## Discussion 2 Precinct A-D:

### Mimico Revitalization Precinct Study

#### Sample Built Form & Height (Precincts A - D)

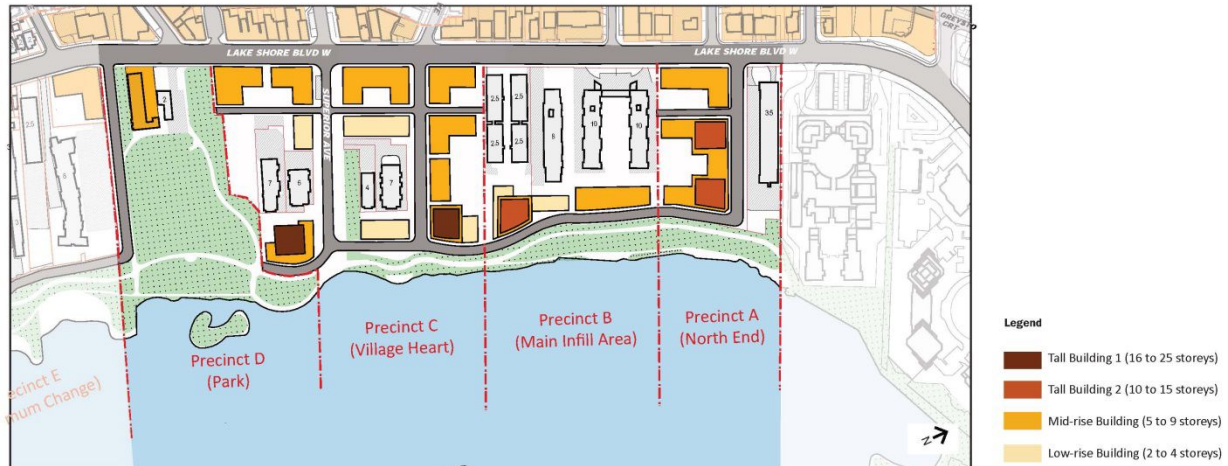
- Mid-Rise building (5-8 storeys) only
- Allow for greater heights up to 12 storeys for proposals that offer exceptional design and benefit to the community
- The property in the park identified as a mid-rise should be purchased by the City and transformed into a recreational facility/community centre with an indoor swimming pool and community meeting spaces
- Support the listing and future designation of the proposed heritage properties

- The public realm is confined in this project as the “new” streets. We believe that the new proposed street on the south side of the park and along the waterfront from Amos Waites Park to the extension of Albert Street should be maintained as public parkland. We recommend adjusting the buildings to adapt to these changes.
- Community members would like to see more overall benefits to the entire community such as a community centre/recreational facility with swimming pool, more parkland, small shops and green grocers throughout the area.

- Public realm should include better/safe connections to the GO Station; the extension of Legion Road to the west giving access to new playing fields; more cycling paths and pedestrian friendly streets
